American Dryer Corp.

No. 156

*February 14, 2001*

*TECHNICAL BULLETIN*

## ADE-320/ADE-330 OVEN CONTACTOR MOUNTING BRACKET CHANGE

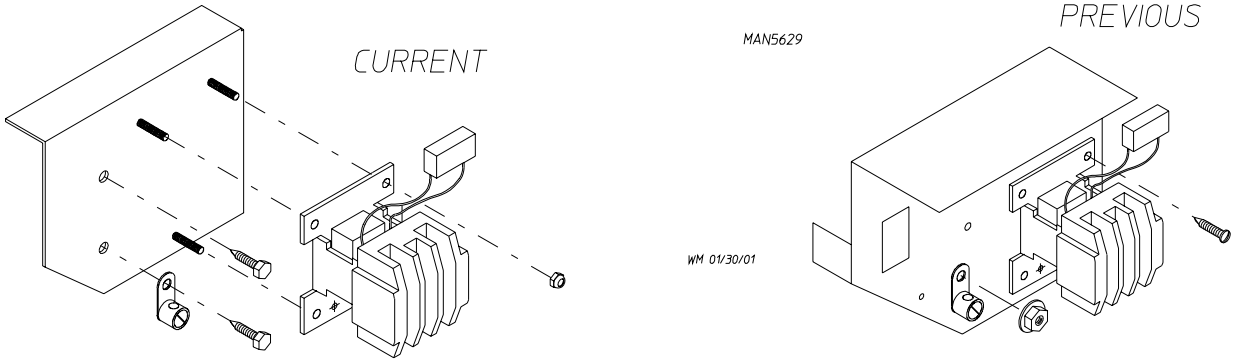
As the result of the recent bearing box change (re: Technical Bulletin No. 155-3) made on the ADE-320 and ADE-330, the oven contactor bracket on the electrically heated version of these models has also changed. As of **NOVEMBER 13, 2000** a new oven contactor bracket is used (**ADC** P/N 850189). This new and the previously used bracket (**ADC** P/N 320655) **ARE NOT** interchangeable.

## PLASTIC MAIN DOORS BEING ELIMINATED

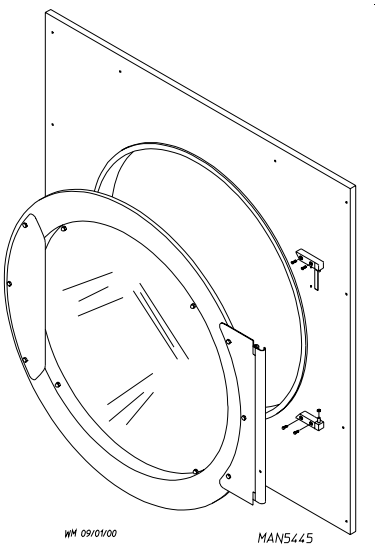
**ALL** use of our plastic main doors as currently used in our coin product line, and a few other applications will be discontinued on **MAY 1, 2001**. As of this May date, **ALL** dryers that are currently being manufactured with a plastic type main door will be manufactured with a "black" steel (cold rolled steel [CRS]) main door and black trim (where applicable). Due to this change, the front panel assemblies as well as door switch assemblies differ. Models presently manufactured without trim will continue to be produced that way. Again, this change will affect **ALL** production where the plastic main door is currently used.

The plastic main door will still be available as parts orders as the two (2) doors or assemblies **ARE NOT** interchangeable.

## AD-81 BLOWER ASSEMBLY NOW DIRECT DRIVE

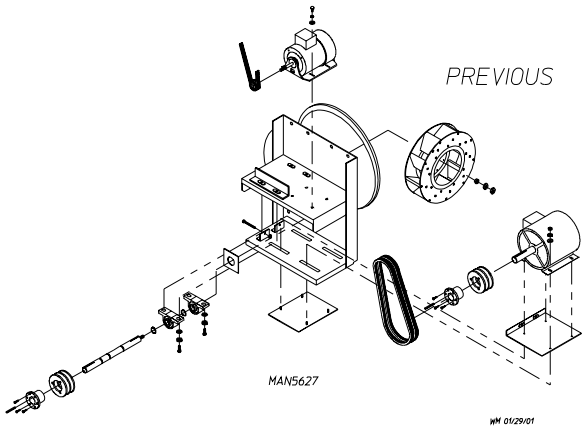
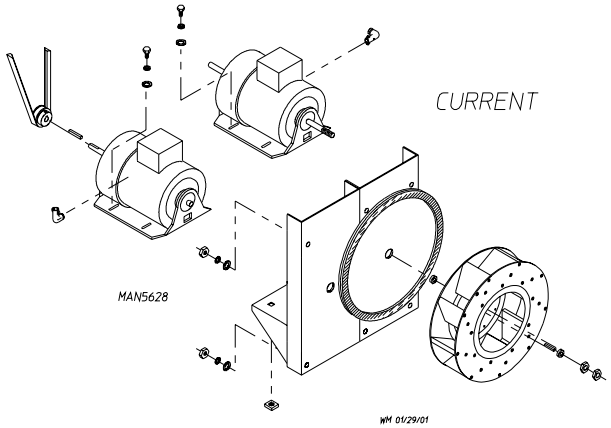
As of **JANUARY 2, 2001** the model AD-81 (both gas and steam) is now manufactured with a direct drive fan/blower assembly opposed to pulley/belt driven type arrangement. As the result of this, the cfm of the ADS-81 (steam version) has been reduced from 2,500 down to 1,700. The exhaust transition piece included with the dryer is now the same for both which is 12" to 14" opposed to the 12" to 16" as included with steam version prior to this change.

## MID-RANGE DRYER MAIN DOOR CHANGE

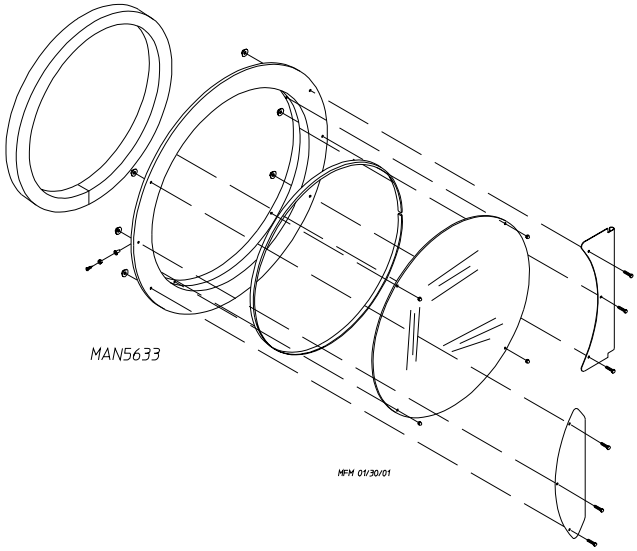
As of **DECEMBER 21, 2000**, the use of silicone used as a cushion or barrier between the glass and the metal main door has been eliminated. This cushion (silicone) has been replaced by a self-adhesive gasket material, which creates a more even seal, and overall better looking finished product. Depending on the color of the main door, there are two (2) gaskets available, black (**ADC** P/N 102360) and white (**ADC** P/N 102359).

This change effects the models AD-78, AD-115ES, AD-120ES, and AD-170ES manufactured with the 37-1/4" main door with mechanical glass fasteners.

## COLD ROLLED STEEL (CRS) MAIN DOOR CHANGE

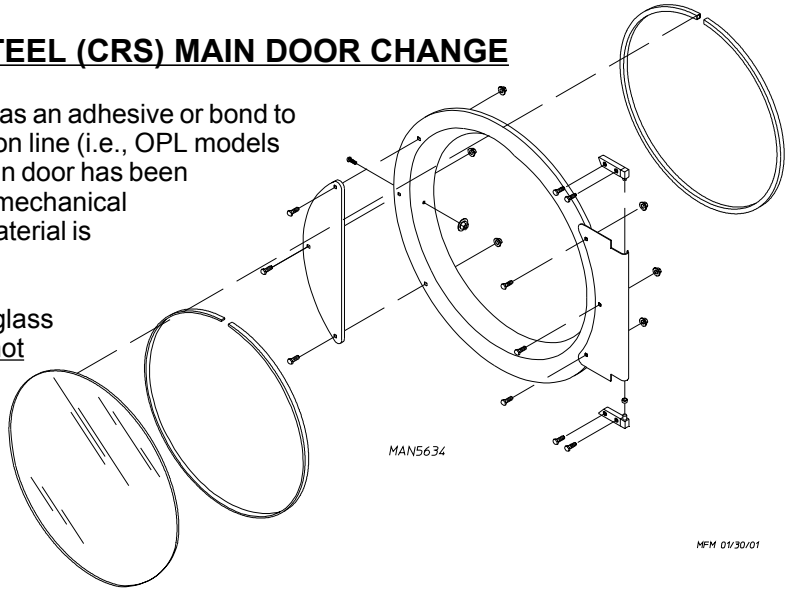
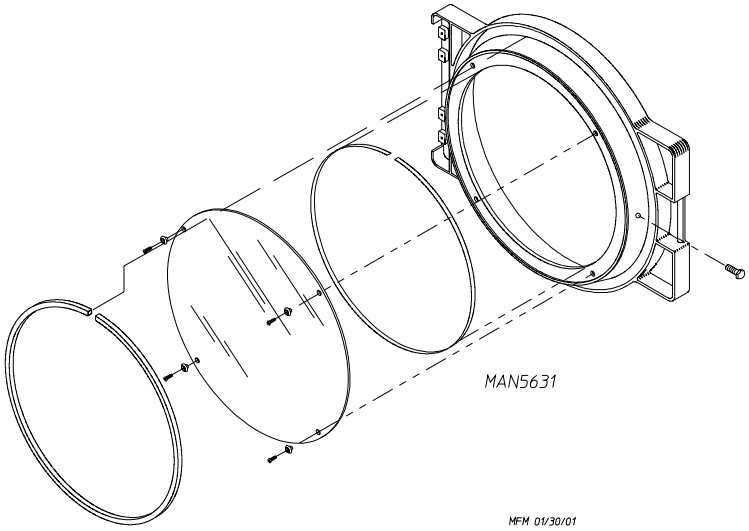
On **FEBRUARY 9, 2001**, the use of silicone as an adhesive or bond to hold the glass in place on the standard production line (i.e., OPL models AD-15 thru 75) cold rolled steel (CRS) metal main door has been eliminated. The glass is now held in place with mechanical fasteners. In addition, a self-adhesive gasket material is used as a cushion between the glass and door.

As the result of this change, the main door glass now differs (has holes in it for fasteners) and is not interchangeable as a replacement for existing units in the field.

**ALL** parts orders for this cold rolled steel (CRS) main door will automatically be filled with this new mechanical fastener type door.
